CONTRACT CHANGE ORDER NO. _____
SHEET ___ OF ___

MARK	DATE	DESCRIPTIONS	BY	CH'D	CCO#
2	04/08/11	SUSPENSION CABLE MISCELLANEOUS DETAILS	GB	MN	185
1	01/28/11	MISCELLANEOUS CABLE SYSTEM DETAILS	GB	MN	37S1

SAN FRANCISCO OAKLAND BAY BRIDGE
EAST SPAN SEISMIC SAFETY PROJECT
SELF-ANCHORED SUSPENSION BRIDGE
(SUPERSTRUCTURE & TOWER)
EAST CABLE ANCHORAGE "E" LINE LAYOUT NO. 2

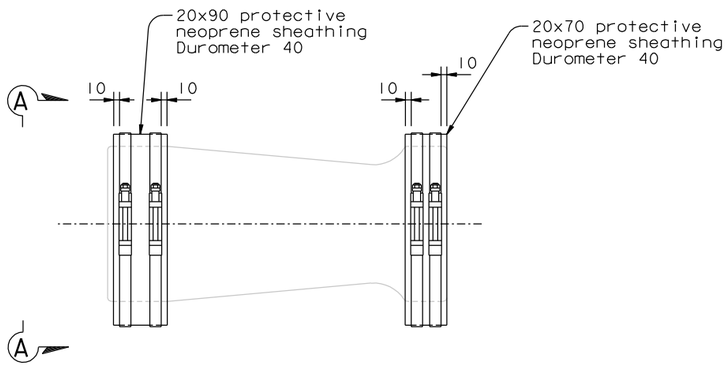
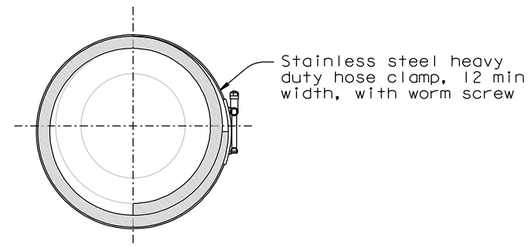
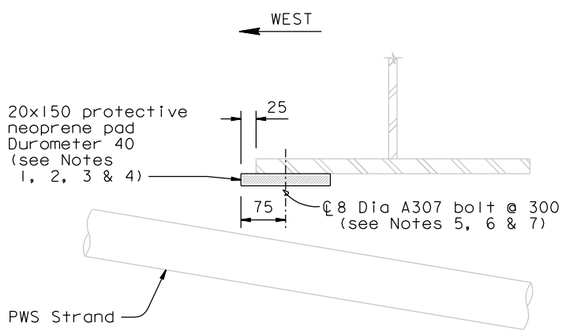
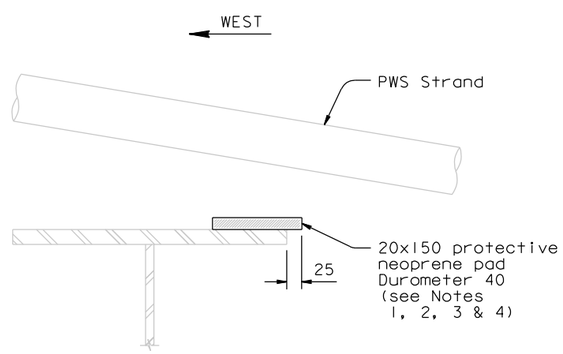
1. Neoprene pad shall be installed prior to free hanging cable installation.
2. At the Contractor's option, the neoprene pad may be installed in segments. A maximum gap of 5 mm is allowable between segments.
3. The Contractor shall provide bonding material and installation procedure for review and approval of the Engineer.
4. The Contractor shall use Chemco Systems CCS grout, Dowel/ Rebar/ Bolt/ LWL, or equivalent, to bond the neoprene pad to the flange.
5. Bolts shall be installed with head on the strand side of the flange, with a 20 Dia washer under the bolt head.
6. Bolts shall be installed snug tight + ½ turn.
7. Nuts shall be installed with thread locking compound.

MARK	DATE	DESCRIPTIONS	BY	CH'D	CCO#
0	03/25/11	SUSPENSION CABLE MISCELLANEOUS DETAILS	MN	GB	185

TYPICAL CABLE BAND DETAIL
1:5

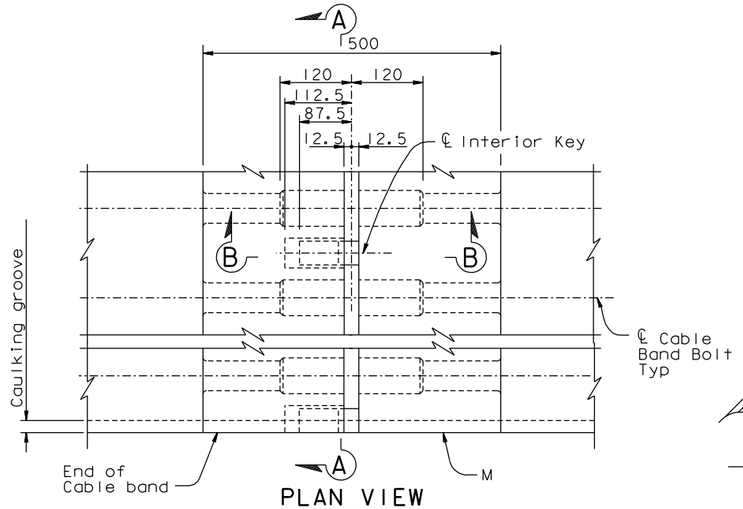
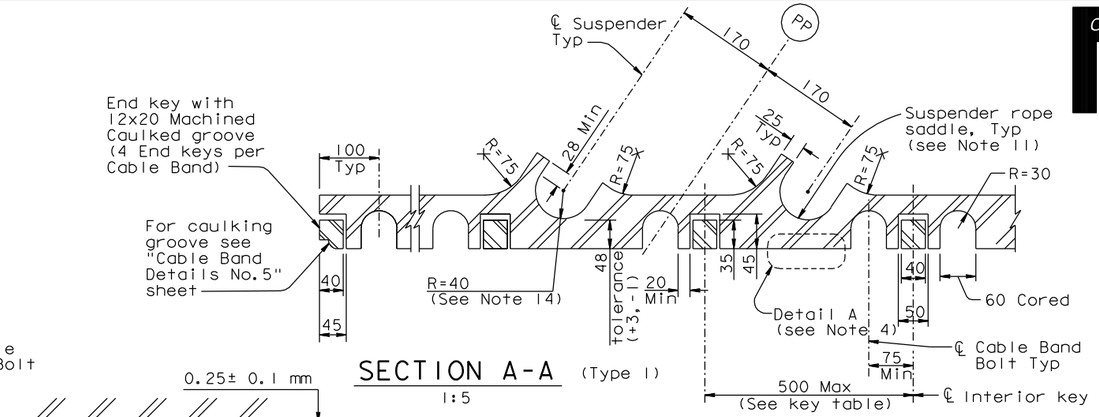
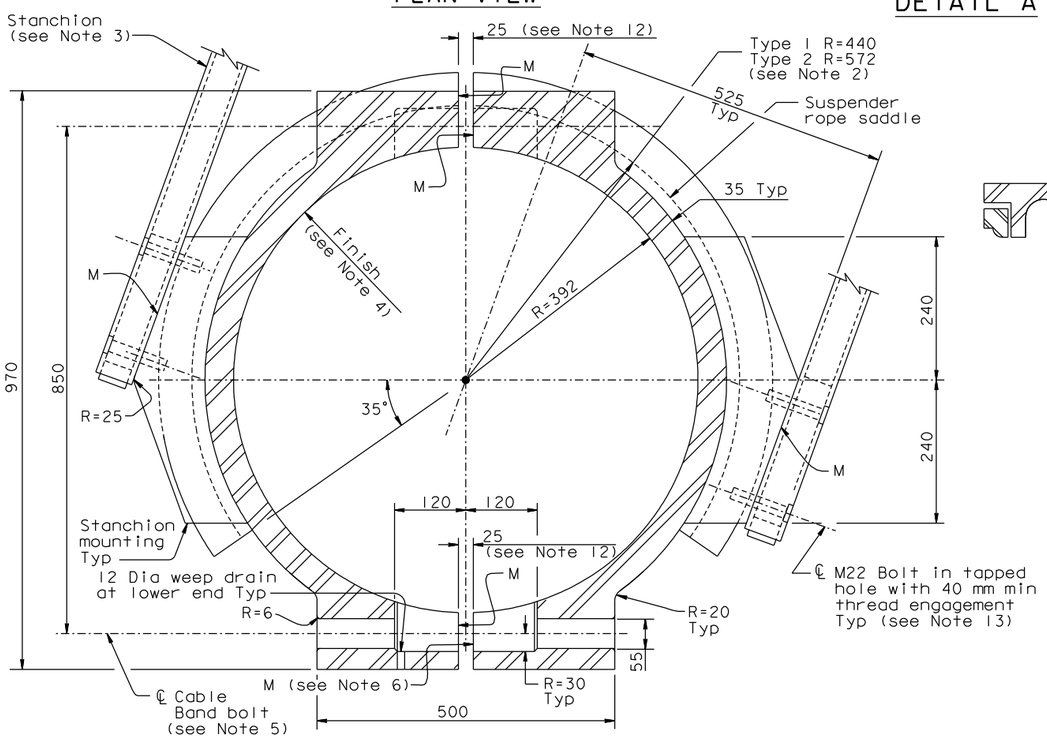
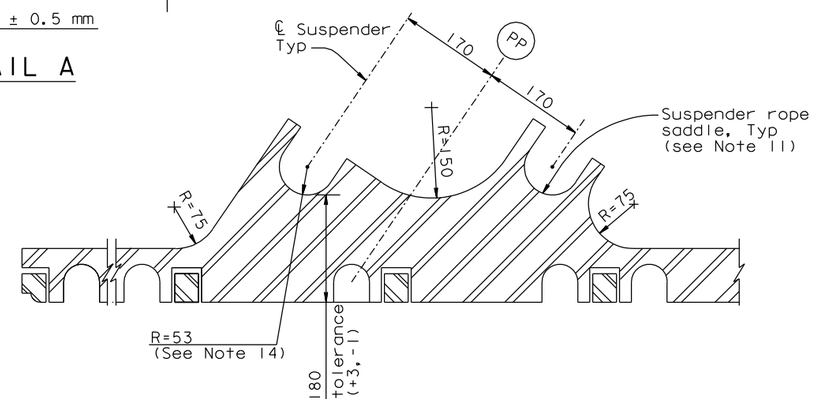
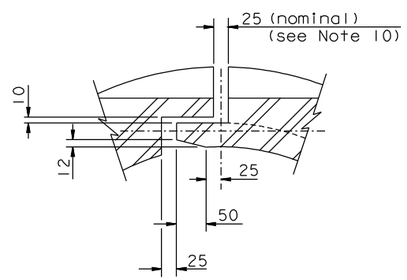
4. Cable band bore shall be finished with 650 cuts per meter with depth of 0.25 mm at right angles to the cable axis, as shown in Detail A.
5. For cable band bolts, see "Cable Band Details No.5" sheet. For materials of cable and bolts, see the "General Notes" sheets.

6. All surfaces identified with the letter "M" shall be spacially placed in the plane identified, within 2 mm. These surfaces shall not deviate in flatness from the specified plane more than ±0.0015 times the length over which the flatness is measured. Surface roughness of exterior surfaces with no machining shall be finished to ANSI 1000.

12. The full depth of the opening between the cable band halves shall be sealed. For sealing details, see "Cable Band Details No.3A" sheet. The top opening shall be fully sealed. The bottom opening shall be fully sealed, except as shown in the Lower End Caulking Detail, see "Cable Band Details No.5" sheet.

SUSPENDER SOCKET TYPE 1 (see Table)
1:2.5

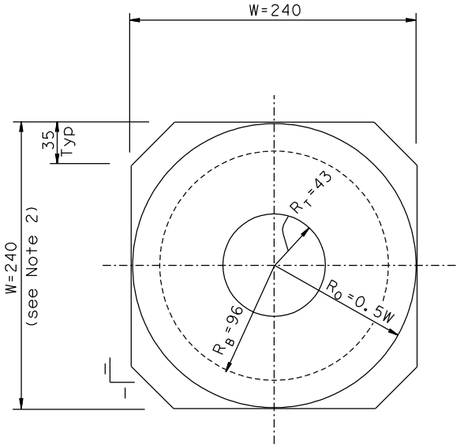
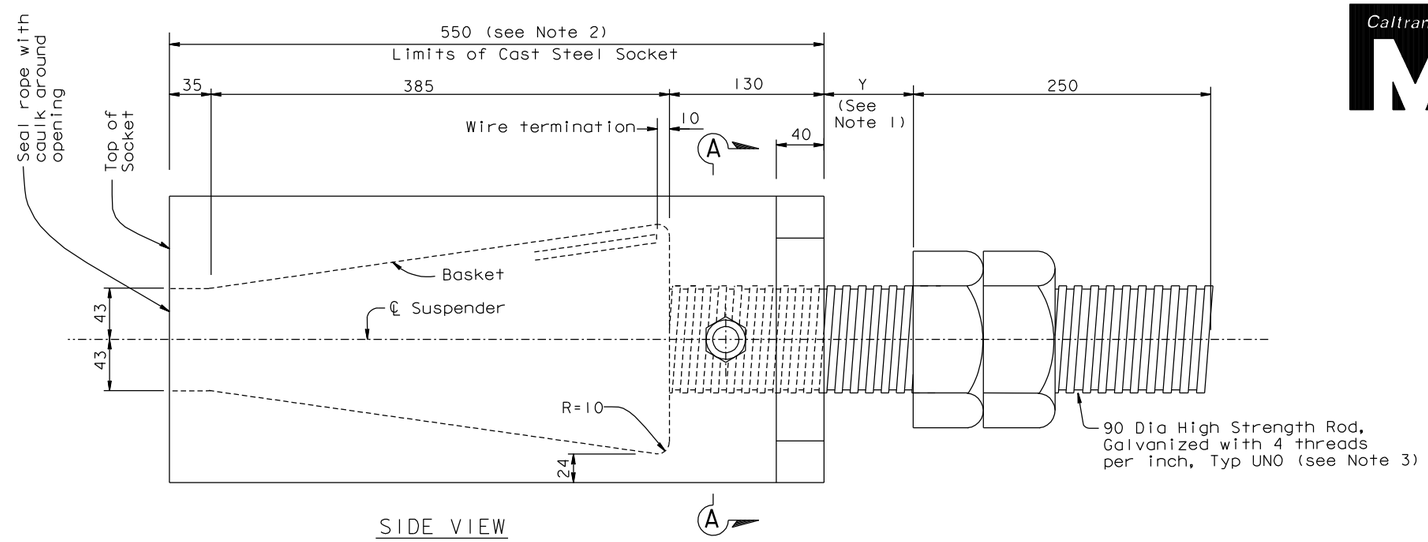
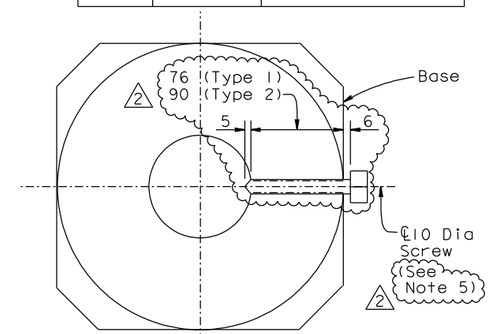
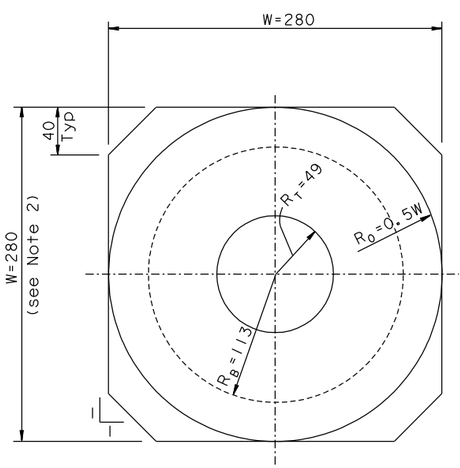
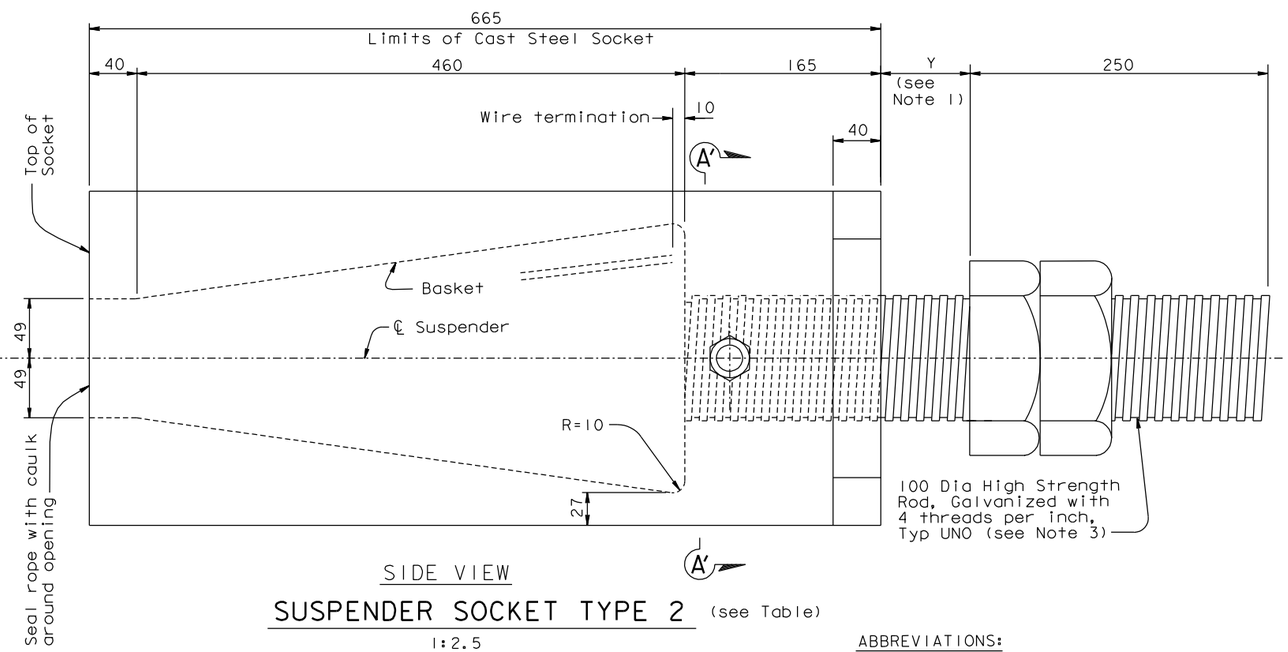
1. For dimension Y, see "Suspender Bracket Details No.3" sheet.
2. All suspender socket dimensions are for information only. The Contractor shall develop socket details consistent with his means and methods and the suspender bracket geometry, and shall submit them to the Engineer for review and approval. The socket dimensions shall be such that adequate prestressing and erection clearance is provided.

For alternate suspender socket, see "Suspender Socket Details (Alternate)" sheet.
3. For suspender socket anchor rod material, see "General Notes" sheets.
4. Rope sizes given for information only. For rope size, see "Suspender Layout No.1" sheet.
5. Loctite Blue 243 or an equivalent thread locking compound as approved by the Engineer shall be applied to the set screw. The thread locking compound shall be applied in accordance with the manufacturer's recommendations. (2)

PLAN VIEW
1:30
(Note: In the plan of the Deviation saddle)

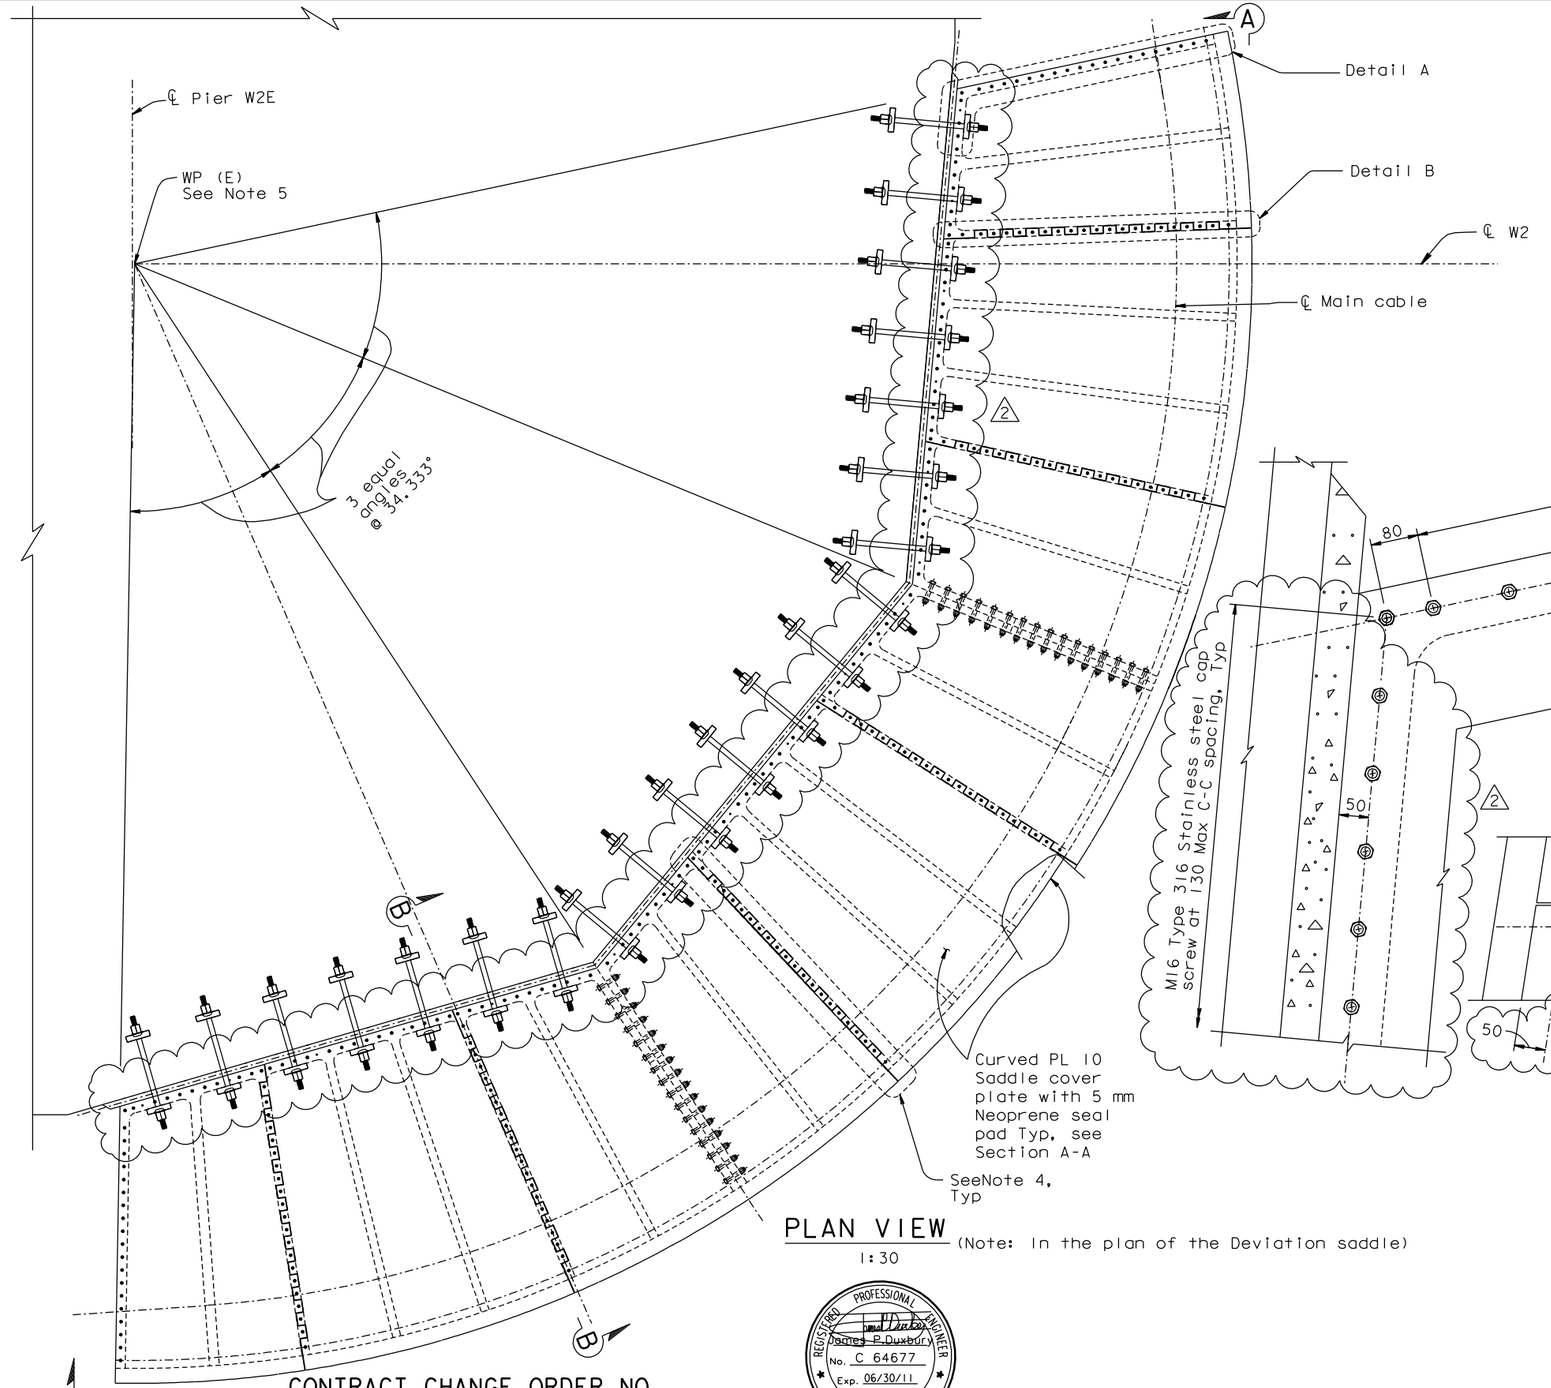
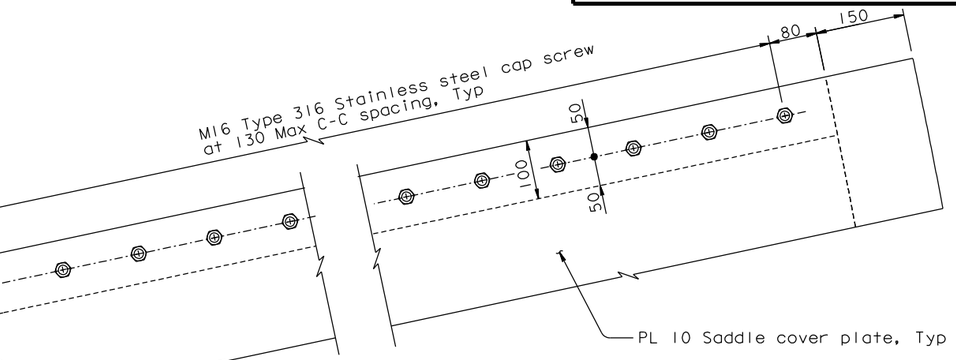
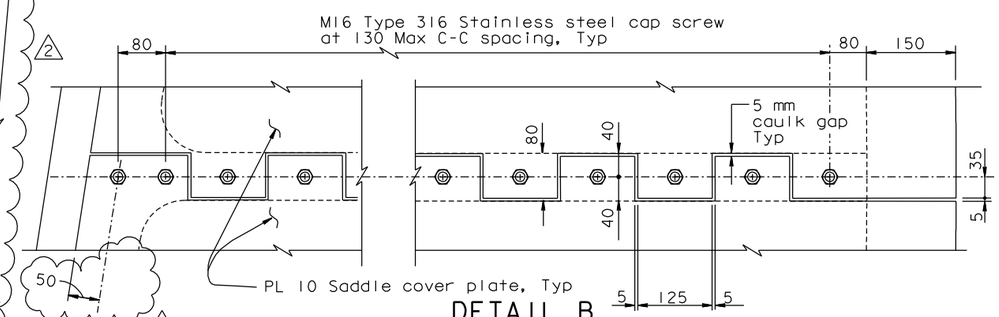
1. For additional details, see "West Deviation Saddle Details" sheets.
2. For Section A-A and Section B-B, see "West Deviation Saddle Housing Details No.2" sheet.
3. All plate shall be ASTM A709M Grade 345, unless specified otherwise.
4. If the Contractor elects to use the West Deviation Saddle Splice Alternate, the joint between the saddle cover plates shall not coincide with saddle splice.
5. WP(E) and WP(W) do not coincide with ℄ of Pier W2, ℄ Pier W2W nor ℄ Pier W2W.

PLAN VIEW (In the plan of the Jacking Saddle)
1:20

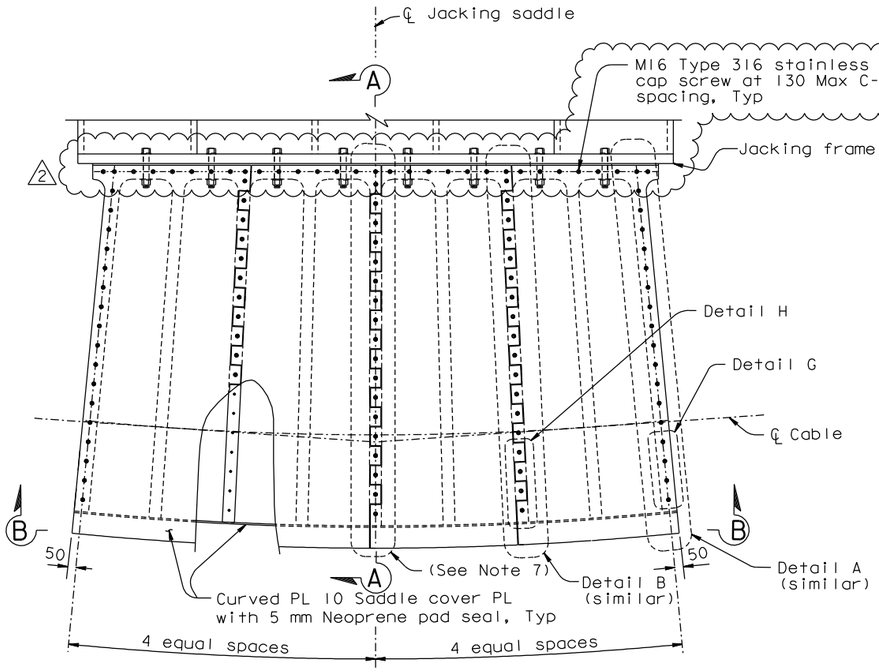
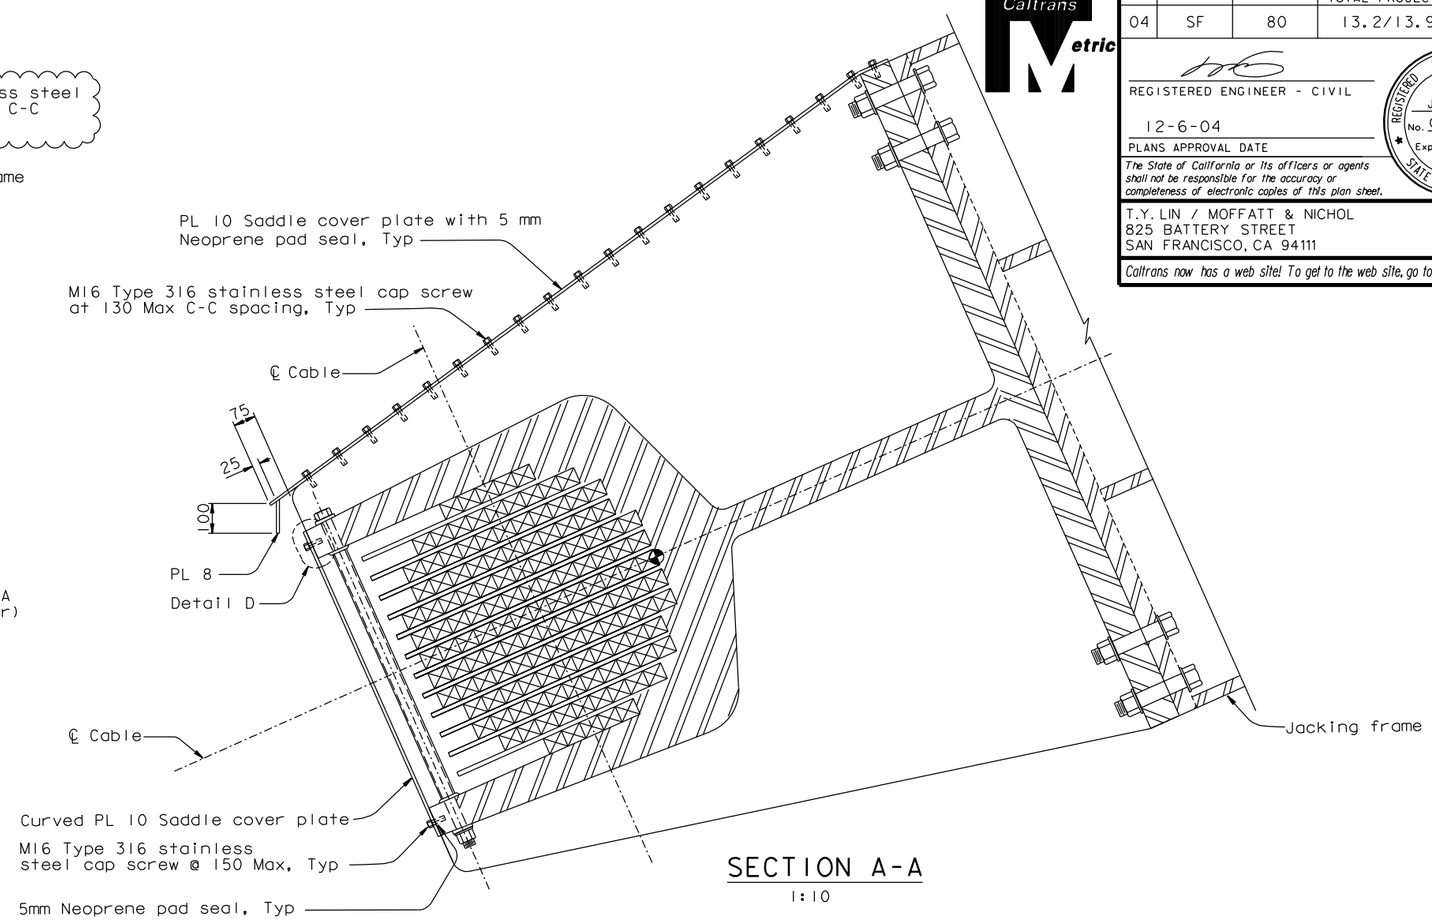
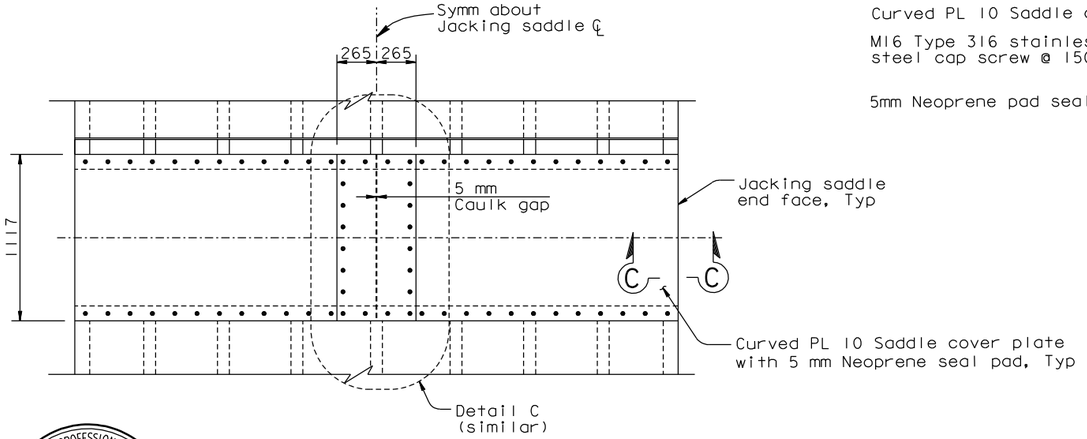
1. For additional details, see "West Jacking Saddle Details" sheets.
2. For jacking frame details, see "West Jacking Frame Details" sheets.
3. For Details A and B, see "West Deviation Saddle Housing Details No. 1" sheet.
4. For Section C-C and Details C and D, see "West Deviation Saddle Housing Details No. 2" sheet.
5. All plate shall be ASTM A709M Grade 345, unless specified otherwise.
6. For Details H and G, see "West Anchorage Access Details No. 4" sheet.
7. If the Contractor elects to use the West Jacking Saddle Splice Alternate, the joint between the saddle cover plates shall be removed.
